APPLICATION NO.	FILING DATE	FIRST NAMED INVENTOR	ATTORNEY DOCKET NO.	CONFIRMATION NO.
10/720,533	11/24/2003	Richard M. Fitzpatrick	GDRMF01O	4395
33076	7590	02/14/2006	EXAMINER	
GEOFFREY E. DOBBIN, PATENT ATTORNEY 4278 SOUTH 6220 WEST WEST VALLEY CITY, UT 84128-6501			KNOX, STEWART	
			ART UNIT	PAPER NUMBER
			3641	
DATE MAILED: 02/14/2006

Office Action Summary	Application No. 10/720,533	Applicant(s) FITZPATRICK, RICHARD M.	
	Examiner Stewart T. Knox	Art Unit 3641

DETAILED ACTION

Drawings
5/9/2005

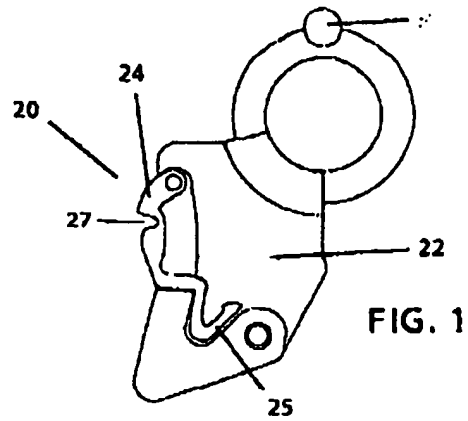
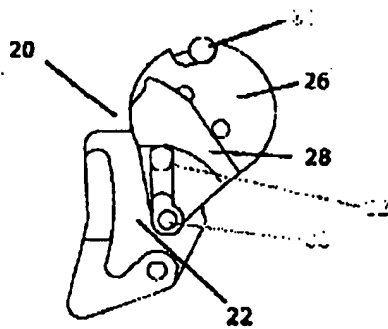
1. The drawings were received on 5/9/2005. These drawings are objected to because the added elements in the drawing are faint and unclear (see attached drawing sheet example labeled "Drawings 5/9/2005").

3. The drawings are objected to as failing to comply with 37 CFR 1.84(p)(5) because they do not include the following reference sign(s) mentioned in the description: point "35," interface node "31," and notch "33." Per the above objection, it may be the case that these elements are labeled in faint and unreadable text. Corrected drawing sheets in compliance with 37 CFR 1.121(d) are required in reply to the Office action to avoid abandonment of the application. Any amended replacement drawing sheet should include all of the figures appearing on the immediate prior version of the sheet, even if only one figure is being amended. Each drawing sheet

6. Claims 1-17 are rejected under 35 U.S.C. 112, first paragraph, as failing to comply with the enablement requirement. The claim(s) contains subject matter which was not described in the specification in such a way as to enable one skilled in the art to which it pertains, or with which it is most nearly connected, to make and/or use the invention. An actuator is claimed in claim 6, sub-paragraph c, item i, but is not labeled in the diagrams and it is not clear what it actually does or where it is. In addition, there is no complete drawing of the device in Figures 1-2f to enable understanding as to the co-operation of parts. The function and operation of element items 24 and 27, the safety latch and catch, is unclear. The purpose of the spring mount, element 25, is unclear. In figures 2b and 2d, element 22 appears to point to two separate parts. Further,

there are several unlabeled parts (the various circles in Fig. 2a and 2e) and it is unclear how, or if, they contribute to the operation of the device.

11. In claim 6, a bicuspid tooth (element 28 on the first drawing sheet) is claimed in communication with a camming mechanism (element 26 on the first drawing sheet), the cusps being positioned on opposite sides of the latch anchor. This is unclear, because the camming mechanism has what appears to be cusps positioned on either side of the latch anchor, yet it is not disclosed as the “bicuspid tooth.” It appears that the “cusps” are intended to refer to the camming mechanism, and not the bicuspid tooth. The claimed “bicuspid tooth” does not appear

to have two cusps at all, whereas the camming mechanism does. If this is the case, then the clarification required above between the “bicuspid tooth” and the “rail interface tooth” further applies to the camming mechanism as well.
